520 WEST GEORGIA STREET (COMPLETE APPLICATION)
DE415285 - ZONE CD-1 (Pending)

- **Proposal:** To develop this site with a 22-storey mixed-use building (commercial and office uses) over four levels of underground parking having vehicular access from Richards Street.

DEVELOPMENT PERMIT STAFF COMMITTEE RECOMMENDATION: APPROVE

A2.01

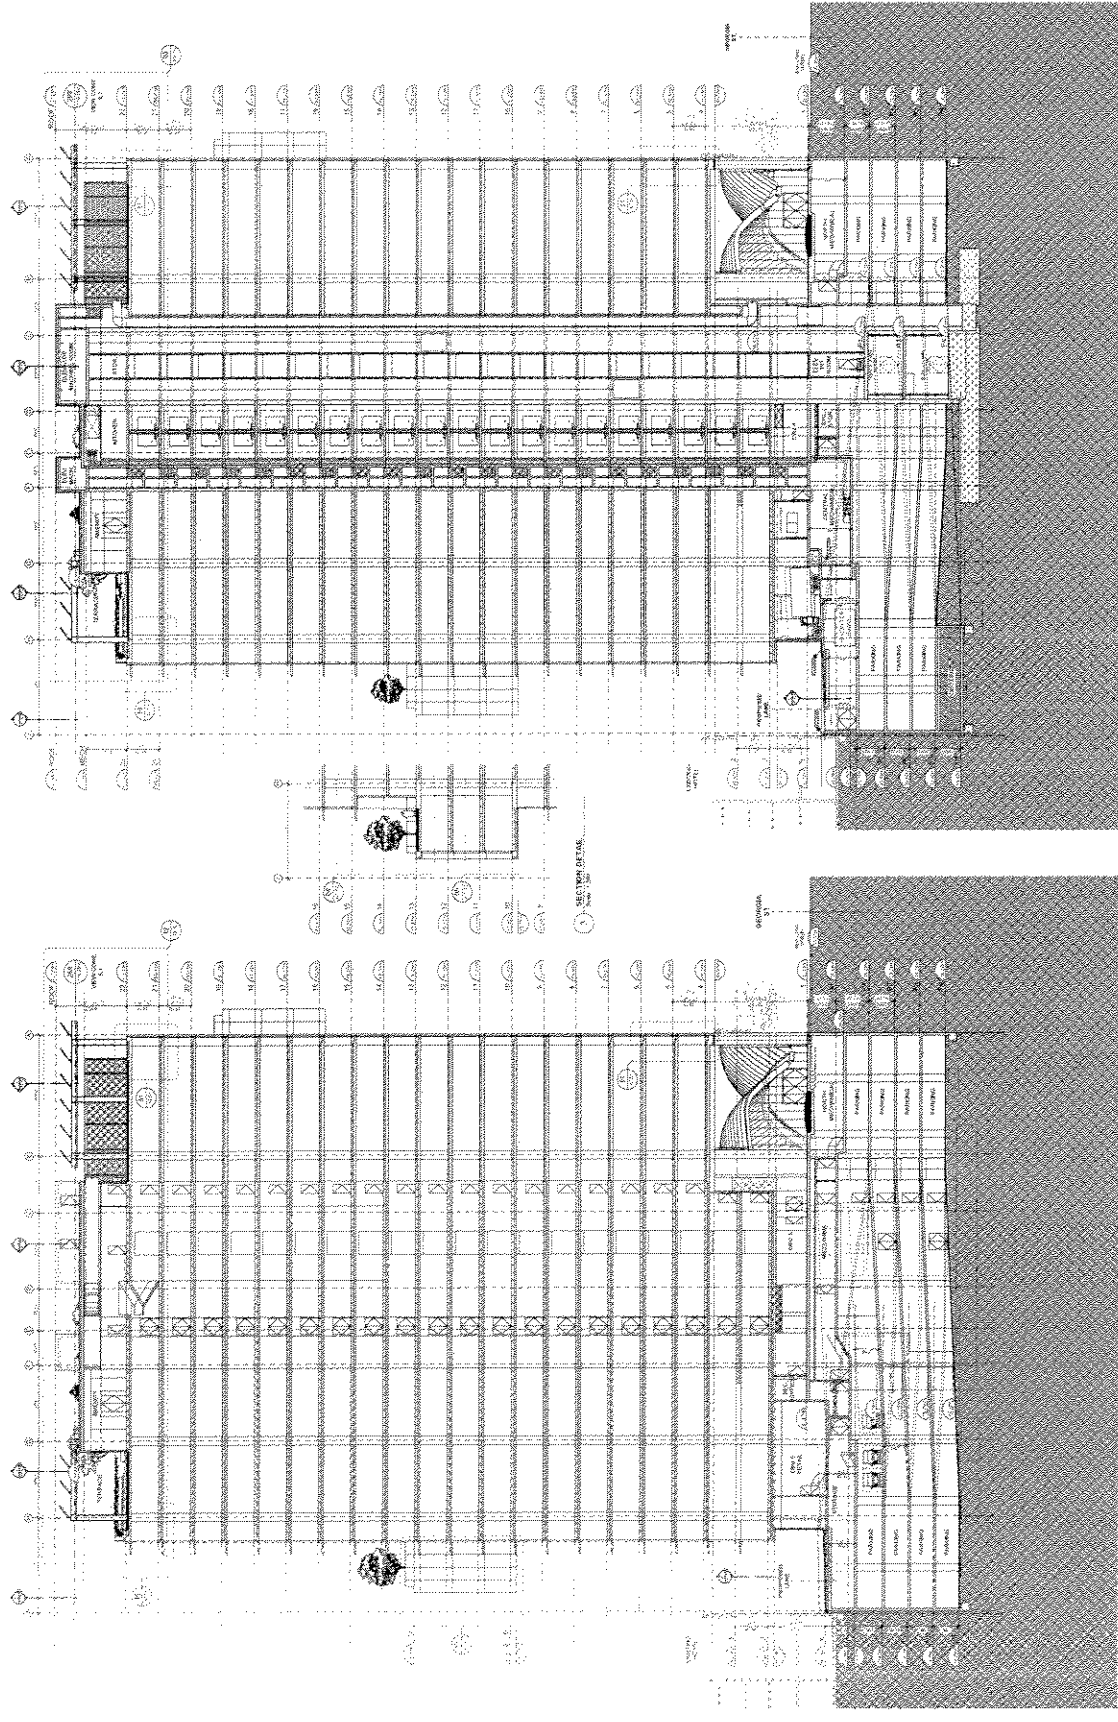
Note to Applicant: Sheets A2.01 and A2.02 show that not all of the lane outlet will have a full 7.62 m (25 ft.) of clearance. Some areas are impacted by the building overhang and will only have approximately 5.33 m (17.5 ft.) of clearance.

Plaza/Lobby/Pavilion—Previous Design

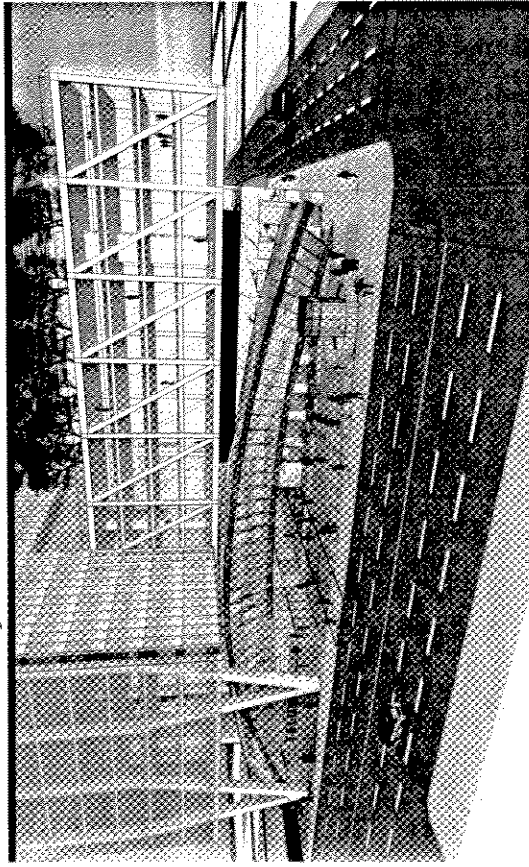
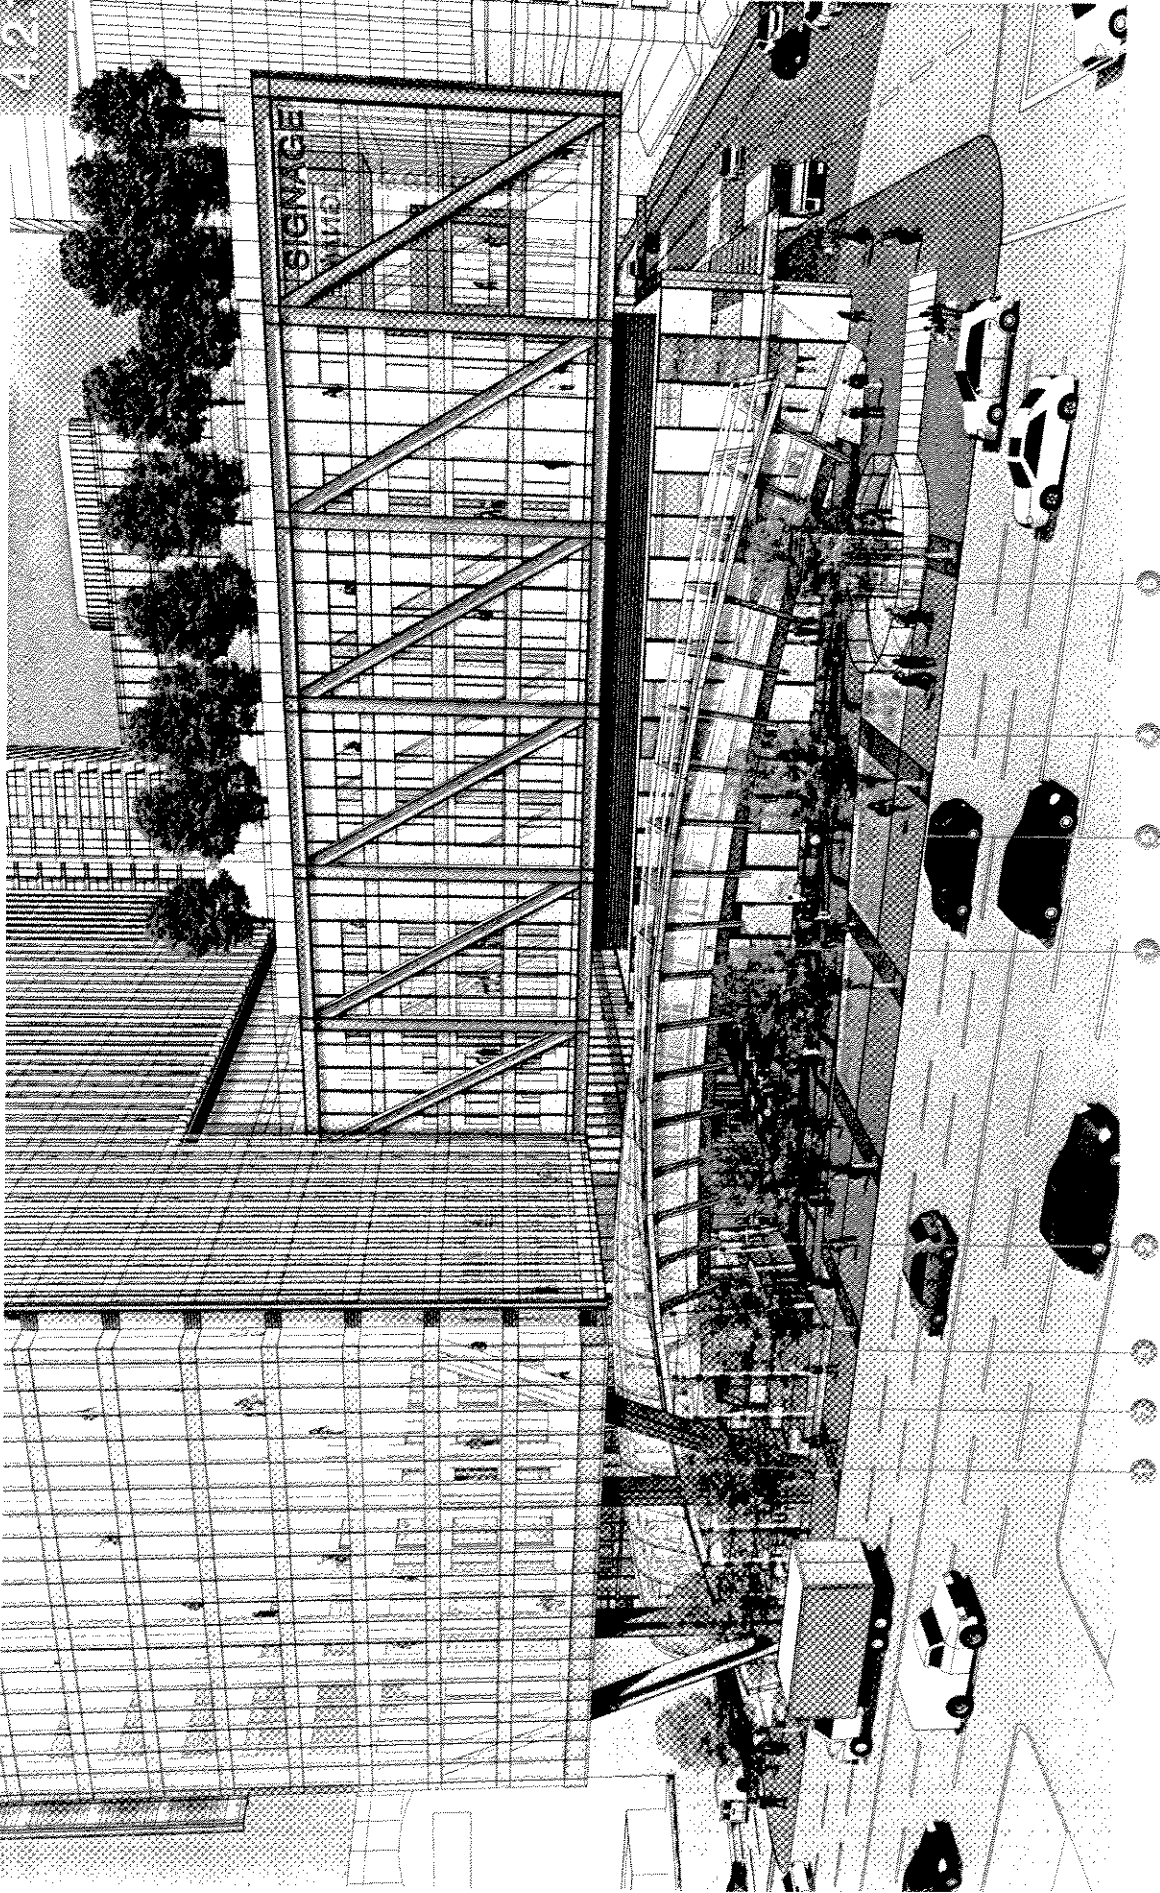
- 1.3 design development to expand opportunities for pedestrian engagement and improved circulation flow into/through the plaza from Georgia and Seymour Streets;

Note to Applicant: Reducing the amount of physical barriers/elements defining the plaza edge from the public sidewalk is desired.

- 1.4 design development to better integrate and transition the plaza surface treatment with the required Georgia Street public realm treatment;

Note to Applicant: Consideration for a lighter palette of paving materials should be given, noting the northerly aspect of this public open space.

The design of the Plaza/Lobby/Pavilion has been developed to engage and enhance the pedestrian experience through the visual and physical connectivity of public and private areas and interior with exterior spaces.

- ① The unifying gesture of the arcing wood Pavilion not only covers the Plaza but also forms the roof structure of the Lobby.
- ② The Pavilion arc has been lowered so that there is no longer an awkward proximity at the building soffit interface.

- ③ To blur the division between indoors and outdoors, the walls enclosing the Lobby will be constructed in frameless structural glass.
- ④ The Plaza pavers will be thin pieces of basalt in a herringbone pattern. They will extend seamlessly into the Lobby, onto the sidewalk, and down the Lane in matching concrete pavers.
